**CITY OF SEATTLE
DRAFT - ANALYSIS, RECOMMENDATION AND DETERMINATION OF
THE DIRECTOR OF THE DEPARTMENT OF PLANNING AND DEVELOPMENT**

Application Number: 3012953
Applicant Name: Swedish Medical Center Cherry Hill
Address of Proposal: 500 17th Avenue

SUMMARY OF PROPOSED ACTION

Figure 2. Proposed MIO Heights

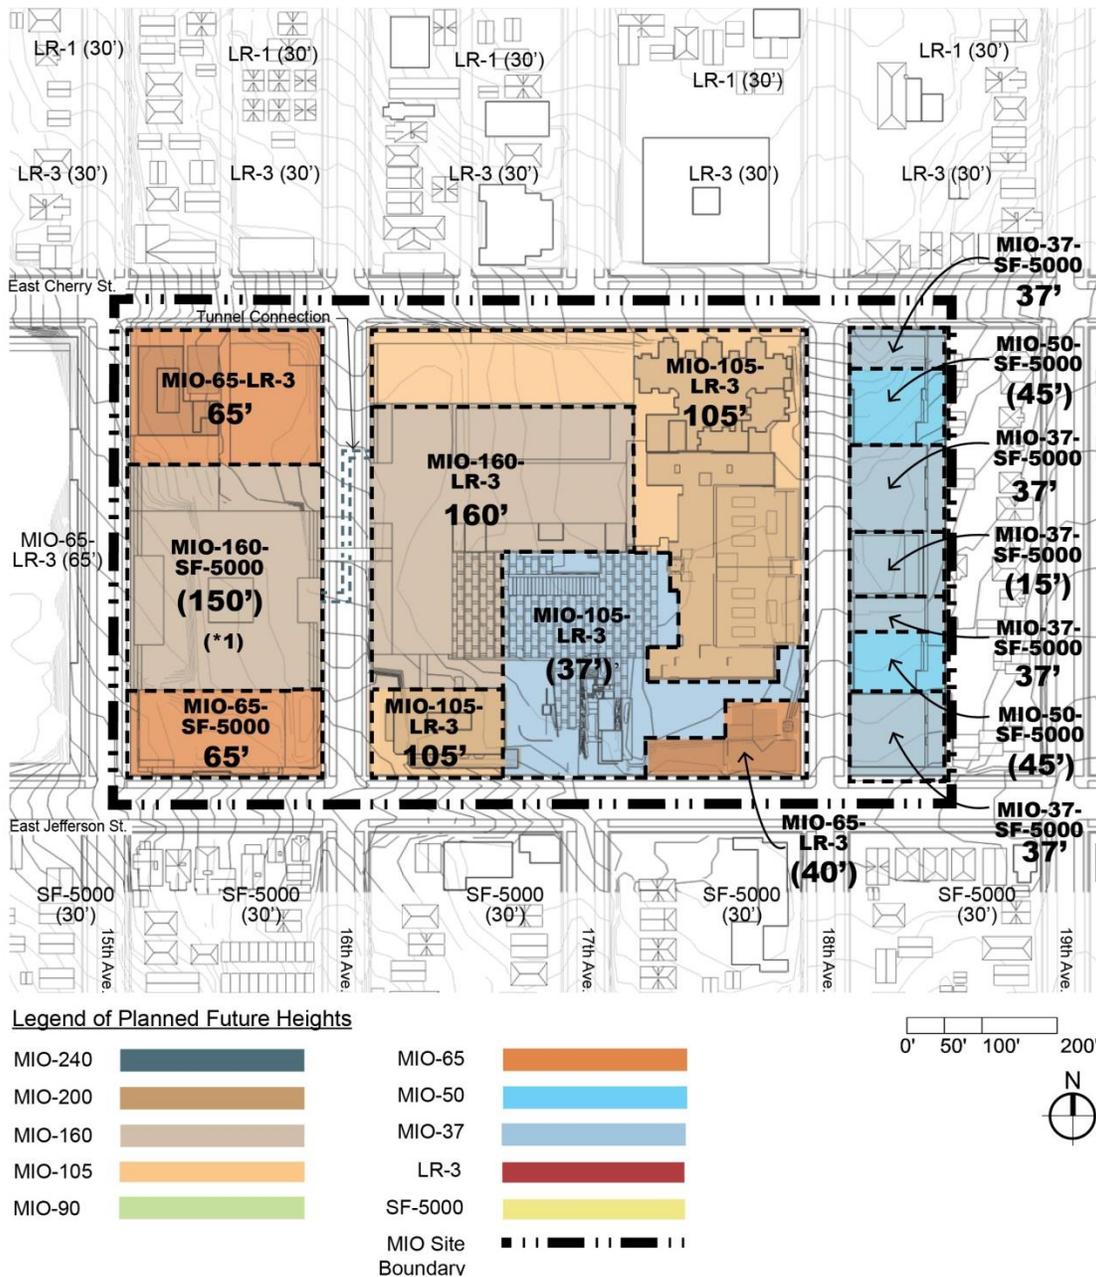
Swedish Cherry Hill proposes to modify its current MIO height overlays as depicted on Figure 2 of this report. As also shown on Figure 2, Swedish Cherry Hill is proposing to condition the heights of certain sites to less than would be allowed within the MIO height overlay district.

DPD concludes that the proposed MIO height districts of MIO-37, -65, 105, and 160 with lower heights conditioned as shown on Figure 2 of this report, and on Figure B-2 through B-10 of the Master Plan, and the proposed setbacks as shown on Figures 10-18 and described in Table B-2 of the Master Plan, as conditioned, fosters an appropriate transition both to the lower neighborhood zones (SF5000 and LR3) to the north, south and east, as well as to the MIO-65 zoning of the Seattle University campus that faces the Swedish Chery Hill campus across 15th Avenue.

Additional height is proposed for three areas of the campus (see Figure 2 of this report). On the West Campus, Swedish Cherry Hill is proposing MIO-160 conditioned down to 150 feet for the central portion of the block. On the Central Campus, Swedish is proposing MIO-160 for a central

The Director recommends **CONDITIONAL APPROVAL** of the proposed modifications to MIO height districts on the western and central blocks as shown on Figure 2 of this report, and include MIO-37, MIO-65, MIO-105, and MIO-160 subject to conditions outlined in Section VII. The Director recommends **DENIAL** of the MIO – 50 (conditioned down to 45) on the east half block as shown on Figure 2 of this report.

Figure 5. Proposed Major Institution Overlay Districts (Conditioned heights are shown in parenthesis)

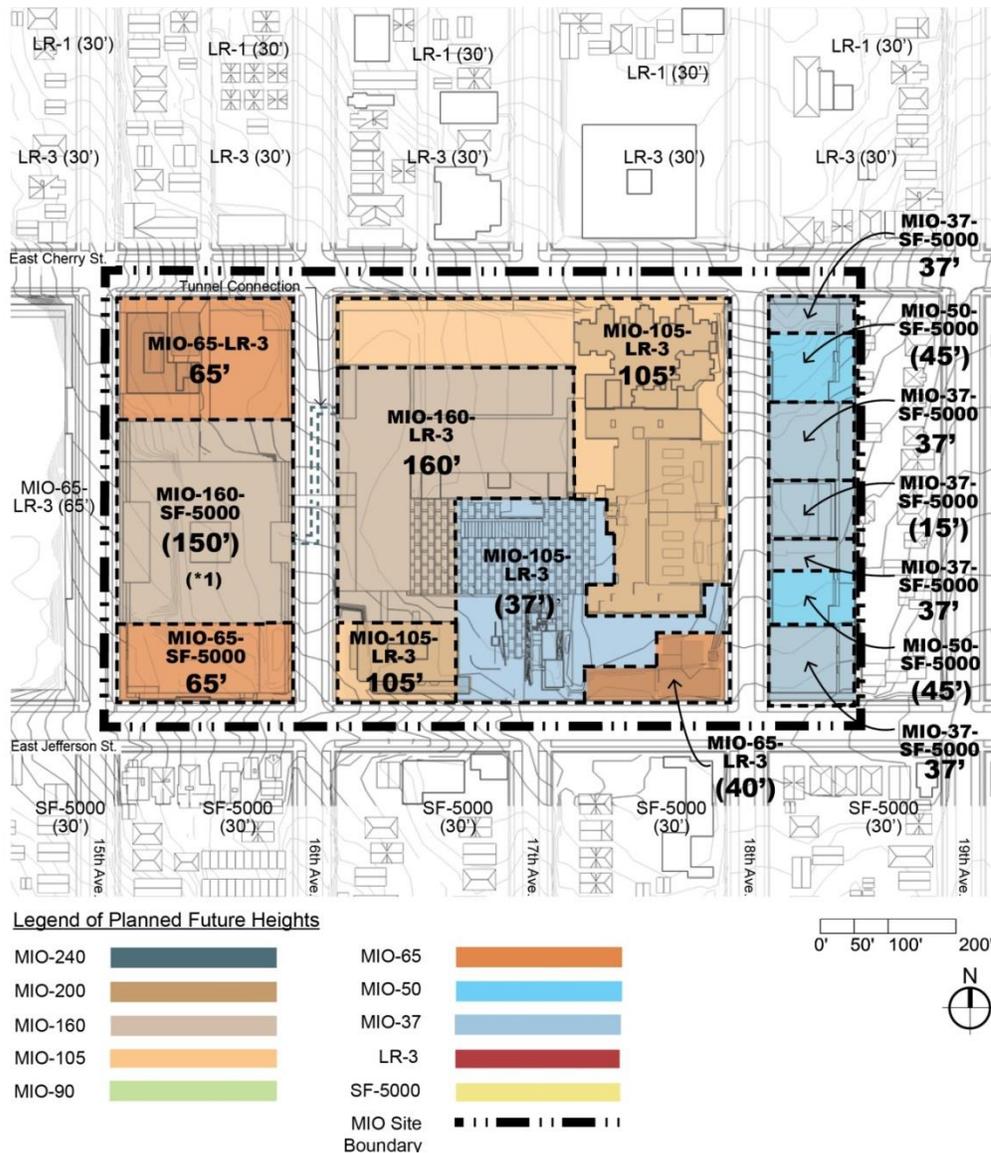
Swedish Cherry Hill is proposing to maintain the existing MIO-65, -105 and -37 on most edges of the campus, and increasing heights in the center of the West Campus, the western portion of the center of the Central Campus, and two sections of the half-block that is the East Campus. Figure 5 identifies both the MIO height districts listed in SMC 23.69.004, and shows in parenthesis lower heights on certain sites that Swedish has agreed to maintain for the duration of the Master Plan. Those lower heights are denoted as “conditioned heights”

Figure 46 No Build and Alternatives 11 and 12 Weekday Peak Hour Intersection Level of Service Comparison

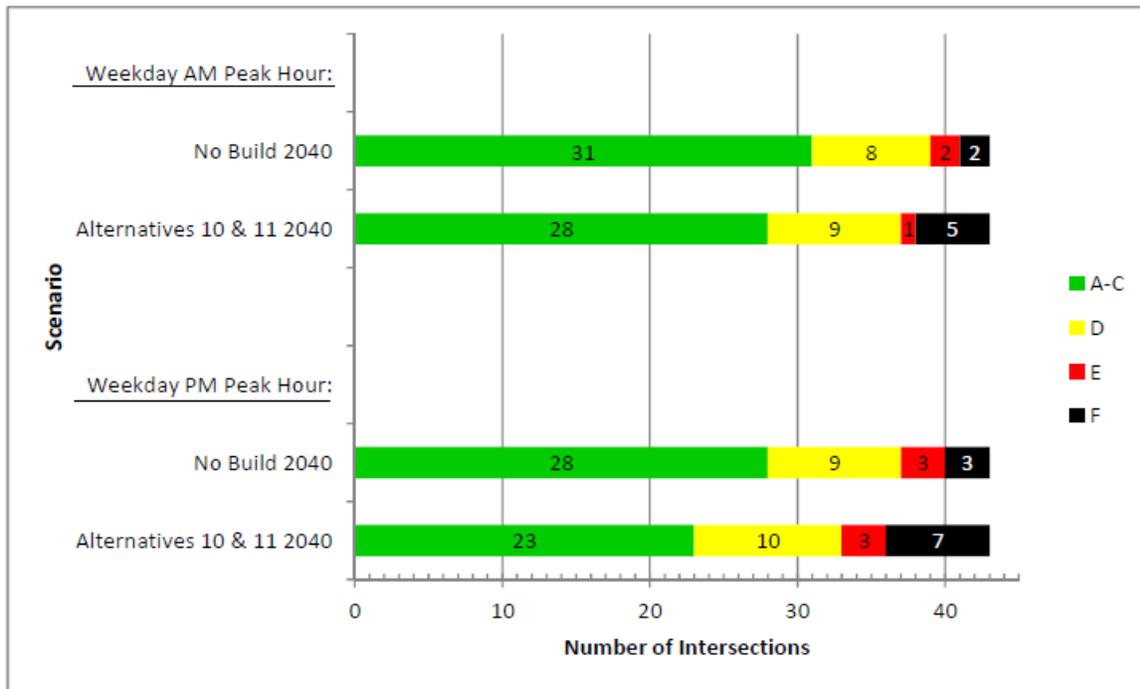
In comparison, with the Proposed Action, by the year 2040, one intersection would degrade from LOS D to LOS E (as compared to two intersections at LOS E for the No Action) and five intersections would degrade from LOS D to LOS F (as compared to two intersections at LOS F for the No Action). In the PM peak hour, by 2040, it is projected that there would be three intersections operating at LOS E (the same as for the No Action) and seven intersections operating at LOS F (as compared to three intersections for the No Action).

This information is summarized on Figure 46 (page C-99) of Appendix C to the FEIS.
